N60478.AR.000075
NWS EARLE
5090.3a

Re: IRP Phase III RI Work Plan Naval Weapon Station Earle (NWSE)
Navy's Response to NJDEP Original Comments
Final Quality Assurance Project Plan (QAPP)
Final Health and Safety Plan

RI Work Plan Comments

NEW JERSEY DEPARTMENT OF ENVIRONMENTAL PROTECTION
MONITOR WELL SPECIFICATIONS FOR UNCONSOLIDATED FORMATIONS

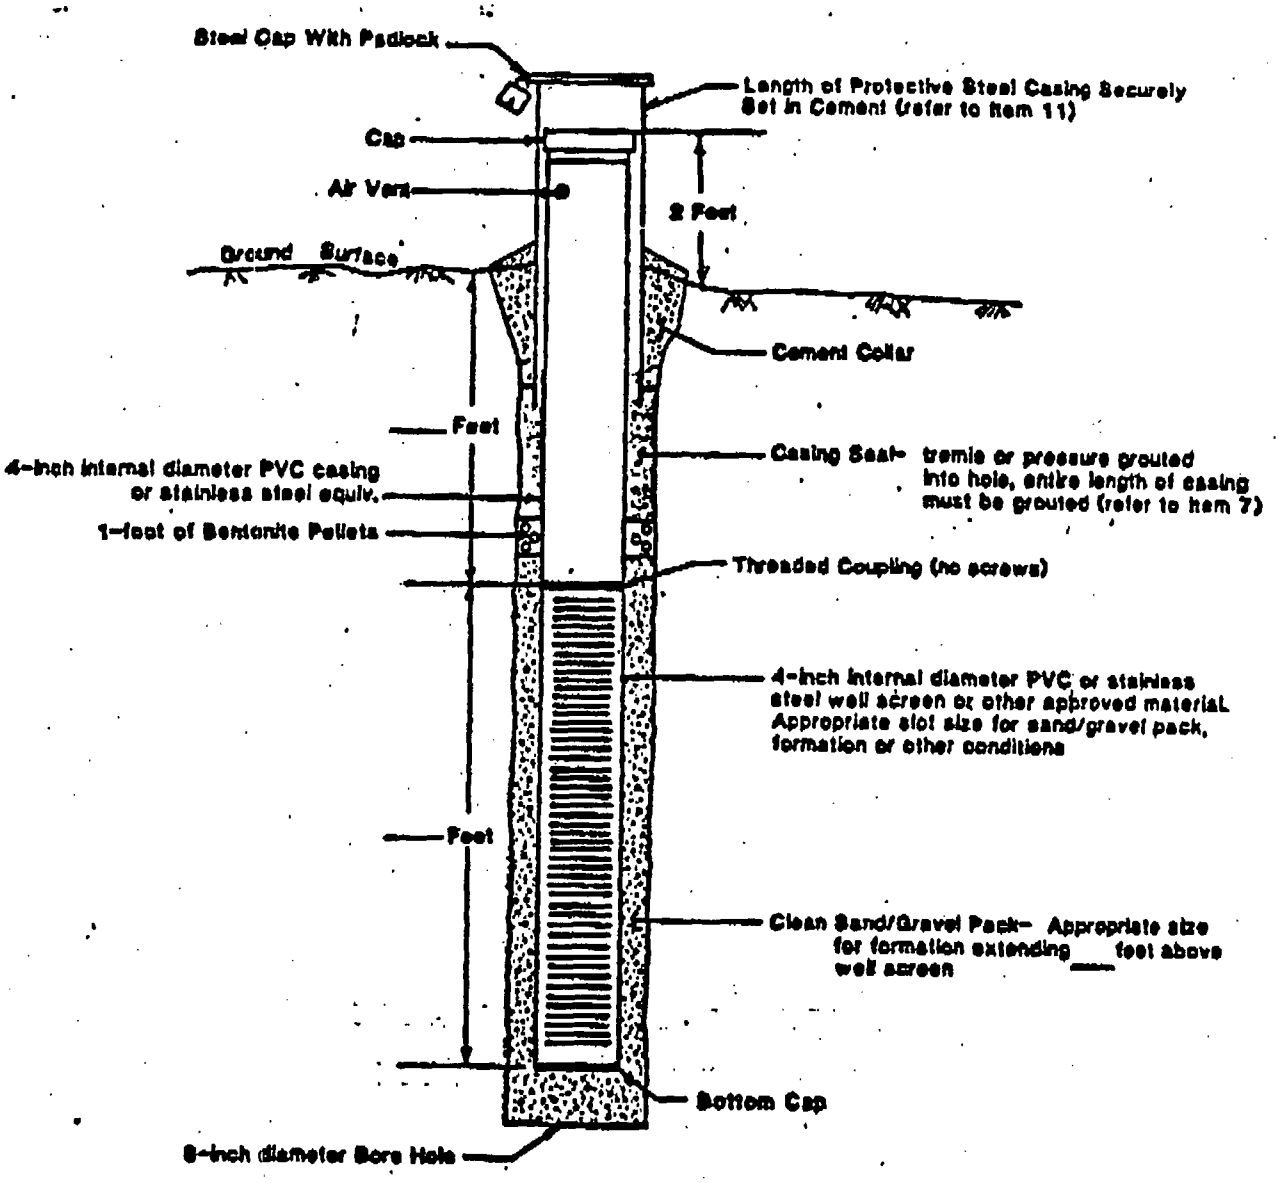
The well construction diagrams provided in the Final draft Quality Assurance Project Plan (QAPP), dated June 1990, page 2-9 are still incorrect. (See Attachment #1, for the appropriate monitor well specifications.)

The figure presented is incorrect and must be revised in accordance with attachment number 1.

FIGURE 5-5 SITE 7 - LANDFILL SOUTH OF "P"
BARRICADES MONITOR WELL LOCATIONS

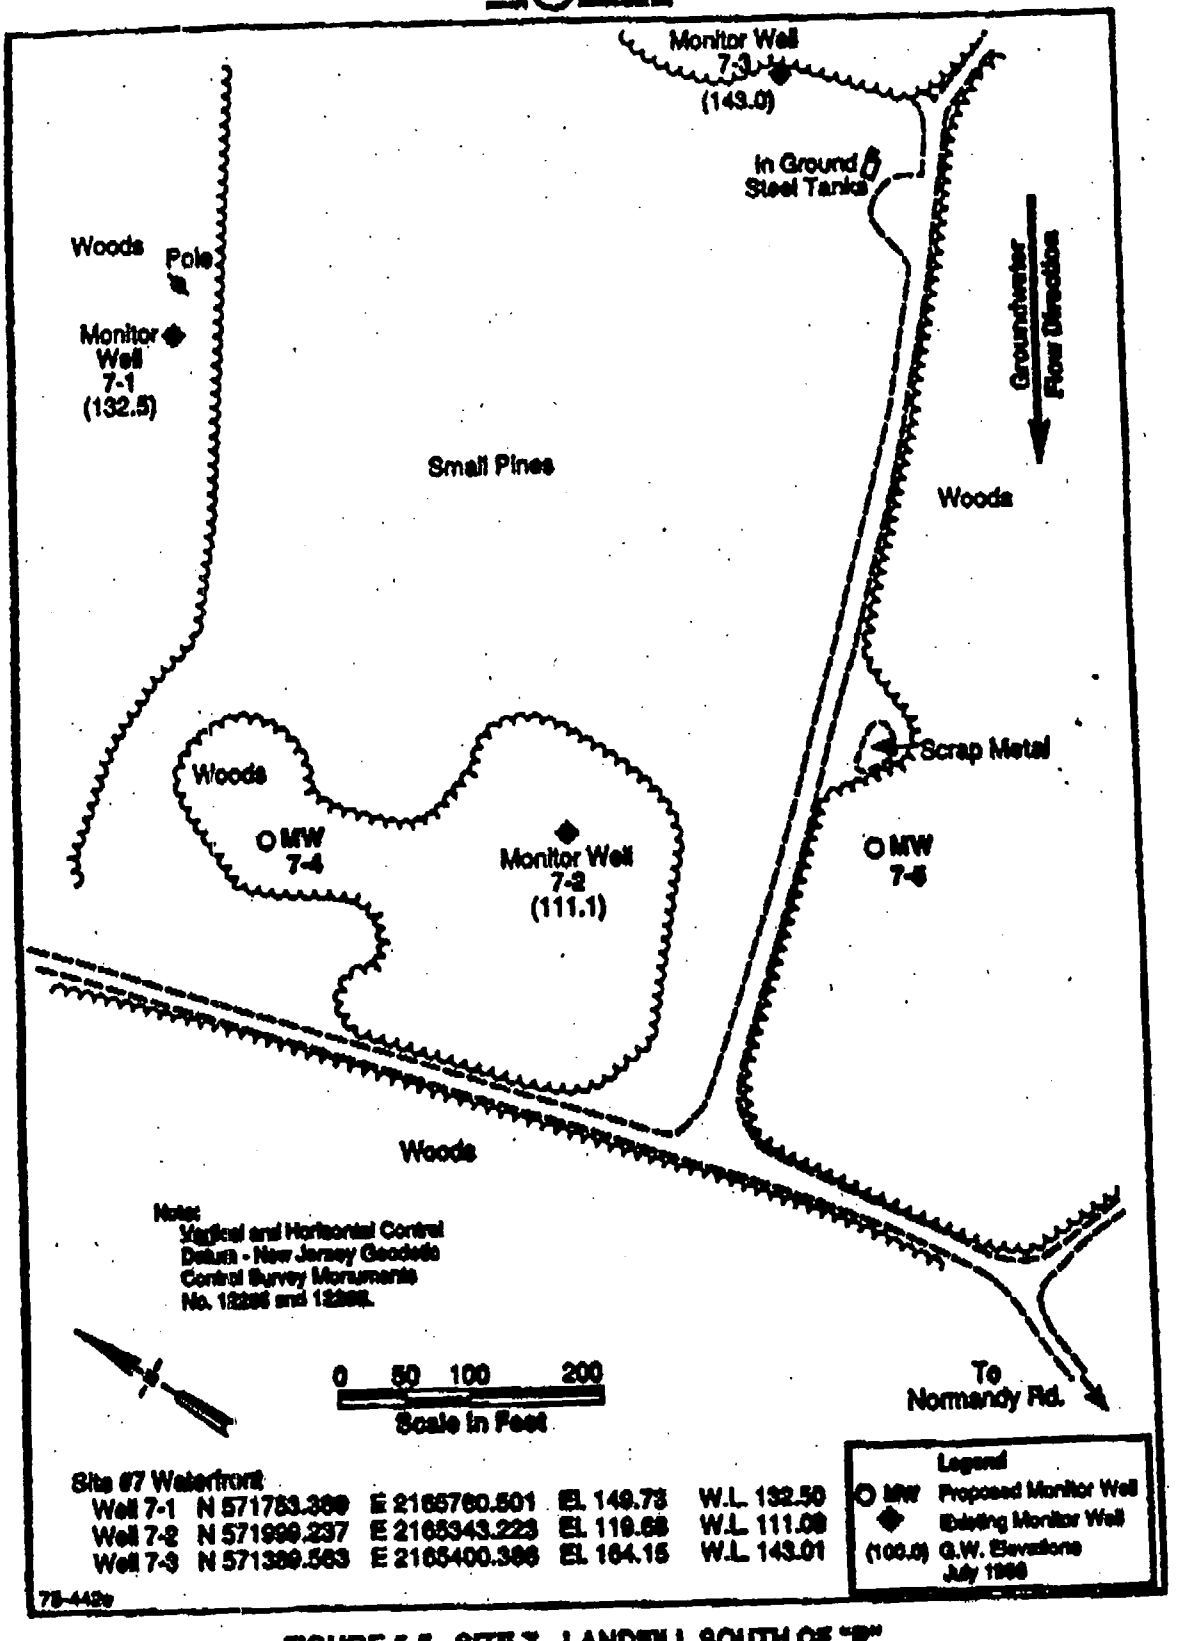
Item 6a, of this section of the response document discusses Compton Creek's approximate location and a drainage way leaving the site. Reportedly, this drainage way is depicted on the revised map in the northern portion of Site 7. (Attachment #2) There is no drainage way depicted on the referenced map, the contractor must revise the figure for Site 7 to incorporate this missing item.

Field Check below comments. Another creek may be closer.
